# **ORIGINATION FORM**

Contact Information:	Standard Plans:
Date: June 17, 2019	Index Number: 711-001
Originator: Ed Cashman and DeWayne Carver	Sheet Number (s): 1, 2, 8, 11, and 12
Phone: (850) 414-4314	Index Title: Pavement Markings
Email: Edward.cashman@dot.state.fl.us	
Added "Dotted Line with Alternating Shadow Markings Sheet 8: Revised right turn lane details. Sheet 11: Revised all details and notes. Sheet 12: Change "A" dimension of 45-degree angle pa	erking to 17'. Add note: "19'-1" if curb stops are used."  ement message spacing. Corrected shadow marking details.  ge will allow greater flexibility to use angle parking, in
Other Affected Offices / Documents: (Figure 1)  Yes No  Other Standard Plans —	Provide name of responsible personnel)
FDOT Design Manual –	
■ Basis of Estimates Manual –	
Standard Specifications –	
☐ ✓ Approved Product List –	
☐ ✓ Construction –	
☐ ✓ Maintenance –	
Origination Package Includes: (Email or h	and deliver package to Derwood Sheppard)

# Standard Plan 711-001 Modification: Change "A" dimension for 45-degree angle parking to 17 feet

Figure 1: Woodstock, GA 20' angle parking stalls

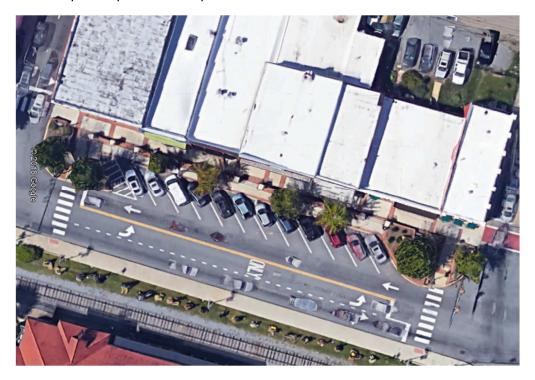
The most common "A" dimension was 16' when measured using Google Earth, and a little more than 16' when measured in person. Woodstock, GA, has a 20' "A" dimension, resulting in significant unused parking space depth (see attached photo.) However, Woodstock also has a relatively narrow travel lane width of 11' adjacent to the on-street parking lane, and it's possible the parking spaces were made intentionally wider to reduce the travel lane width for traffic calming. This would still be an option under the proposed change to Standard Plan 711-001, but a lower "A" dimension also frees up space for other ways to improve roadway conditions as described above.

Figure 2: Angle Parking with AASHTO P Vehicle

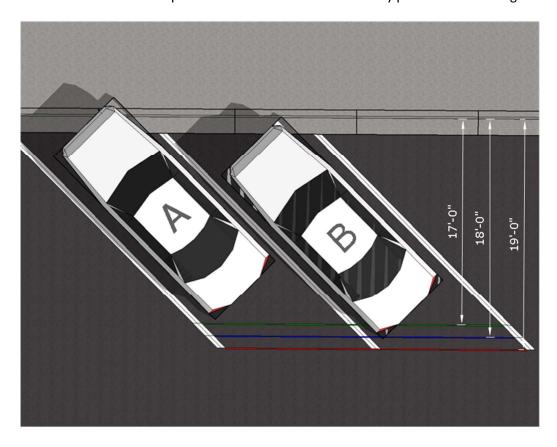
The 17' deep angle parking space was diagrammed using the AASHTO "P" vehicle. The diagram shown in Figure 2 depicts two "P" vehicles, labeled "A" and "B". The AASHTO P 7'x19' envelope is indicated with a box around the vehicles. The vehicles are parked in 45-degree angle parking spaces per Standard Plan 711-001.

Vehicle A is parked with the front wheel in the gutter pan and the front end overhanging the sidewalk. In the absence curb stops, one normally curbs a vehicle when parking, pulling forward until the wheels either touch the curb or the edge of the gutter pan is detected. A fully-curbed vehicle would be even deeper into the parking space.

Vehicle B is parked with its entire AASHTO 7'x19' envelope within the parking space, with no curb overhang. Curb stops would be required to consistently achieve this use of the parking space, as the vehicle's tires do not reach the gutter pan, and drivers would have no other indication of where to stop.

The diagram indicates a 17' deep parking lane (shown by the green line) is sufficient to contain the AASHTO "P" vehicle when parked as vehicles are conventionally parked in this configuration.

PAVEMENT MARKING FOR PARKING

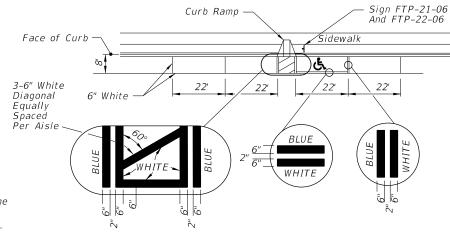
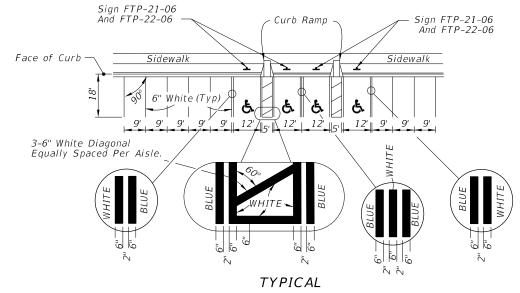
## ADDED TO THE NOTES

Use of pavement symbol in accessible parking spaces is optional, when used the symbol shall be 3' or 5' high and white in color.

= PAVEMENT MARKING FOR PARKING =

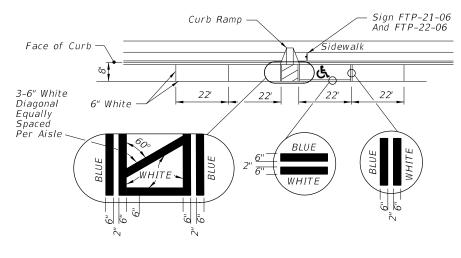
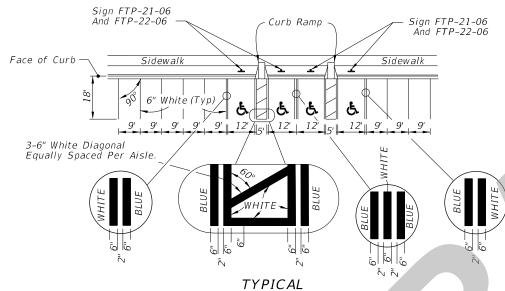
On Sheet 12 of 13 of Standard Plan 711-001 PAVEMENT MARKINGS, under the PAVEMENT MARKING FOR PARKING section, in the DIMENSIONS table, change the "A" dimension for 45-degree angle parking to 17'. Add an asterisk with the note "\* 19'-1" if curb stops are used"

DIMENSIONS						
6 🗴	"A"	"B"	"C"	"D"	"E"	
45°	17'-0"	12'-9"	7'-0"	24'-0"	17'-0"
